Reference: 15S1478000

15 April 2016

**RE: AUSTRALIAN TECHNOLOGY PARK, EVELEIGH
RESPONSE TO CONSULTATION**

Figure 1: Existing Condition Peak Hour Intersection Turning Movement Volumes

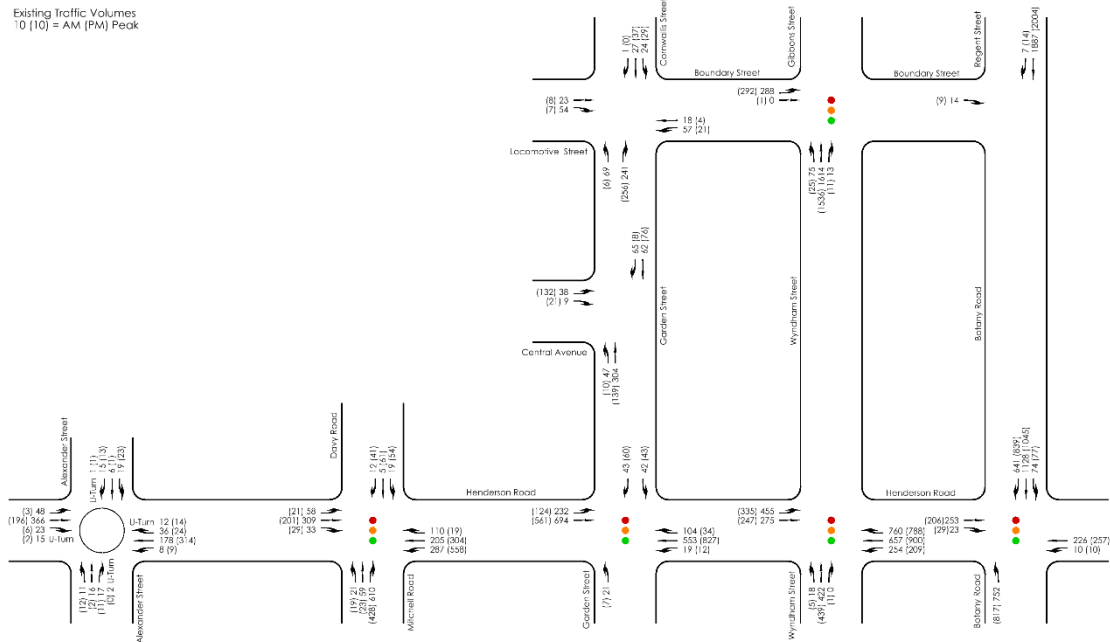
• The applicant had a meeting with TfNSW in December 2015. The traffic modelling undertaken as part of the Transport Impact Assessment does not include the intersections TfNSW advised the applicant to model. TfNSW considers any traffic impacts from the ATP development on the intersections will have impacts to bus travel times. The traffic modelling should be revised to include the intersections listed in Section 3.1 and any identified impacts to bus travel times, mitigated. The intersections include:

Intersection performance assessment is not sufficient. Assessment of the future performance of intersections should be provided for additional intersections including:

These intersections were assessed as requested by TfNSW and the letter dated 1st February 2016 summarising these results is attached to this letter. This letter concludes "the analysis indicates the assessed intersections would continue to operate satisfactorily in the future following the completion of the proposed development. In the future, the assessed intersections would continue to have the same level of service as that found under existing traffic conditions albeit the average intersection delay would marginally increase.

These intersections were assessed as requested by TfNSW and the letter dated 1st February 2016 summarising these results is attached to this letter. This letter concludes "the analysis indicates the assessed intersections would continue to operate satisfactorily in the future following the completion of the proposed development. In the future, the assessed intersections would continue to have the same level of service as that found under existing traffic conditions albeit the average intersection delay would marginally increase. *In addition:*
